# **Windsor Street Exchange Functional Plan Project**

**Public Engagement: What We Heard Report**

**February 11, 2022**

Report Prepared by: WSP Canada Inc.

Figure 1: Option A Overview

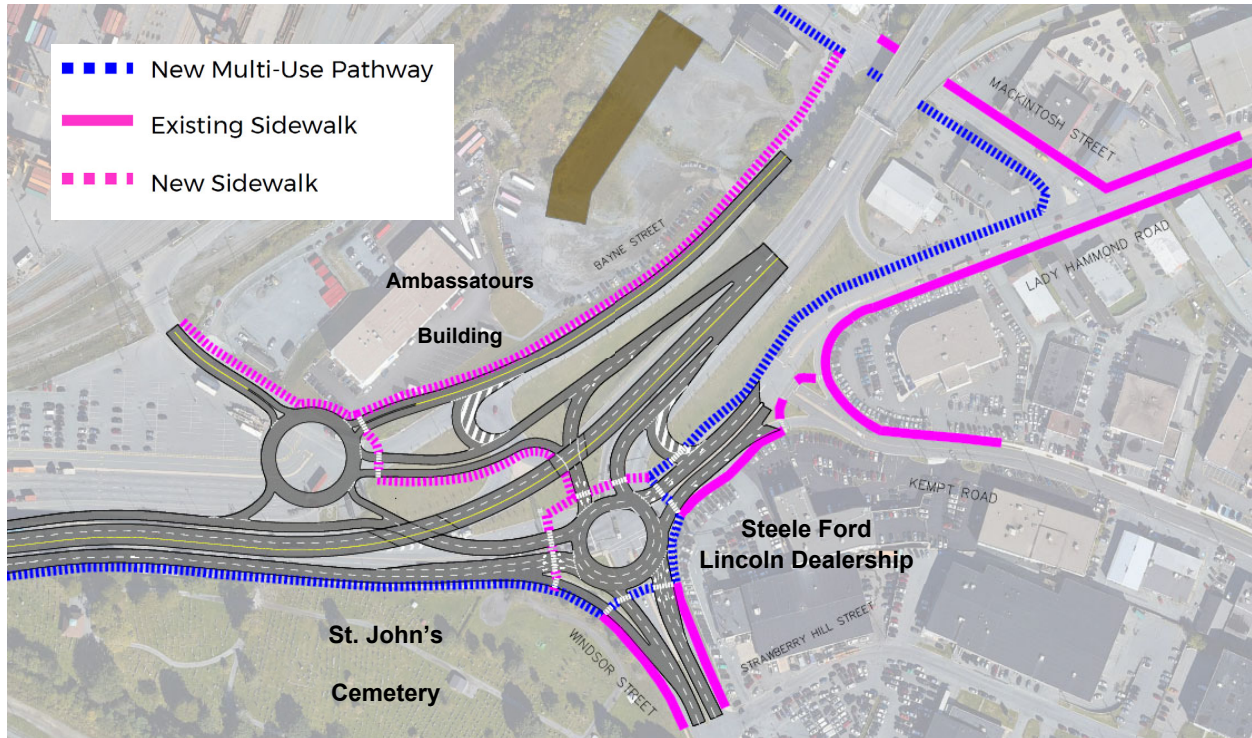
- Concerns with roundabouts (user knowledge, wait times, transport trucks turning radius) (146)
- Concerns with AT (safety, poor access, connections) (66)

- Prefer Option A (54)
- Don't like the design at all / won't solve the issues (49)
- Lack of AT priority (dedicated lanes, MUP, etc.) (33)
- Roundabouts are good (30)

- Concerns that the study area does not include Joseph Howe (30)
- Concerns with navigation (23)
- Traffic density is too high for AT (17)
- Lack of transit priority (13)

- Traffic density is too high for roundabouts (13)
- Concerns with traffic to/from Fairview Cove Terminal (13)
- Grade separate AT crossings are needed (11)

- Reduce to one roundabout (5)
- Lack of greenery (5)
- Maintenance of roundabouts (snow removal) (4)
- More lanes needed than proposed (3)
- Removes the option for panhandlers (3)

- Concerns with construction (3)
- Many environmental benefits (1)
- More community feel in this option (1)

Figure 2: Option B Overview

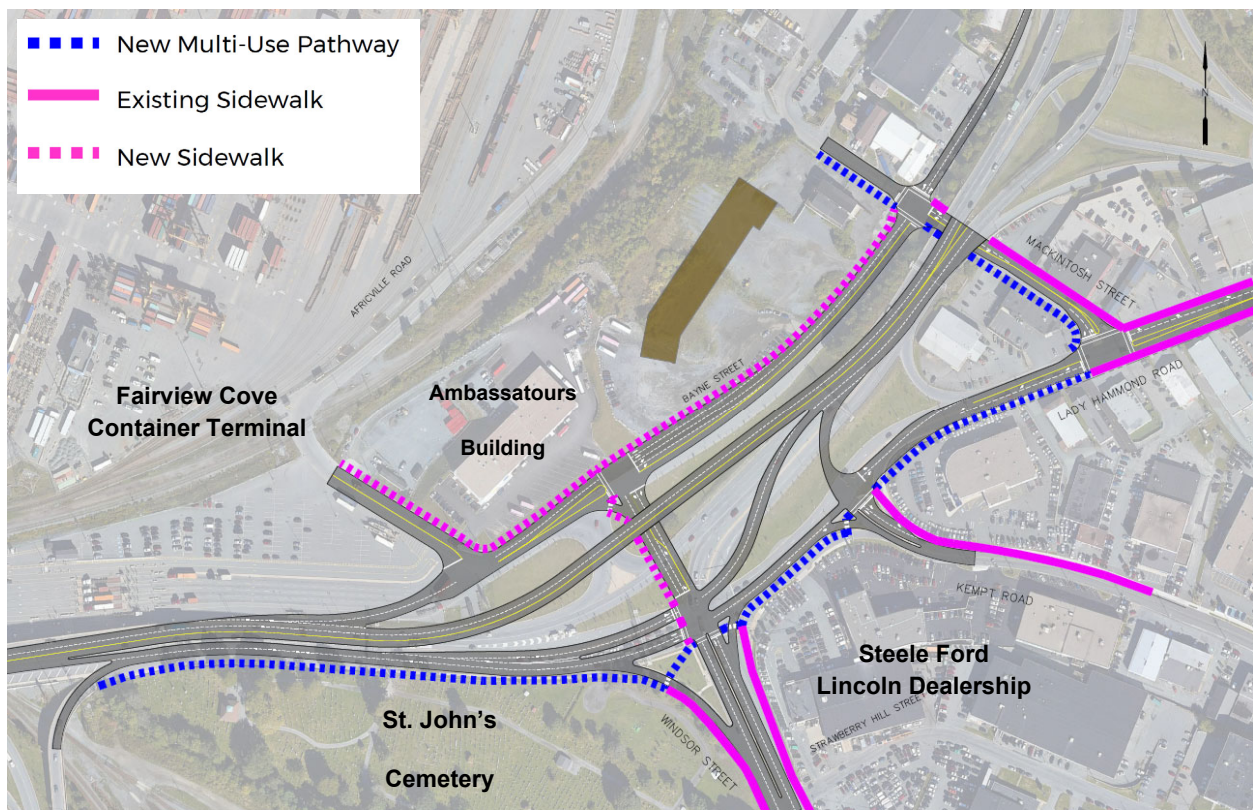
- Don't like design / won't improve current issues (111)
- Concerns with the use of traffic lights/number of intersections (103)
- Prefer Option A (roundabouts are the better choice) (55)
- Prefer Option B (46)
- Lack of AT priority (dedicated lanes, MUP, etc.) (28)
- Concerns that the study area does not include Joseph Howe (26)
- Concerns with AT (safety, poor access, connections) (24)
- Concerns with traffic to/from Lady Hammond Road (23)
- Seems like the better (safer) option for AT users (21)
- Concerns with navigation (19)
- Lack of transit priority (19)
- Traffic density is too high for AT (18)
- Easier to navigate than Option A (18)
- No roundabouts (indicated as a good thing) (18)
- Vehicles are still required to cross/merge multiple lanes (safety) (17)

- Concerns with traffic to/from Fairview Cove Terminal (16)
- More costly option (12)
- Direct connection from the Bridge to Bedford Highway (11)
- Environmental impact is far greater than Option A (6)
- Concerns with panhandlers (4)
- Maintenance (4)
- Concerns with length of construction (3)
- Wayfinding required (3)
- Better traffic movement during peak traffic (2)
- Lack of greenery/beautification areas (2)
- Mitigates delays if accident occurs (2)
- Tunnels for more green space (2)
- Concerns about raised taxes due to the proposed changes (1)
- Provides opportunity for future development (1)
- Transport trucks should be limited to what times they can travel through the exchange (1)
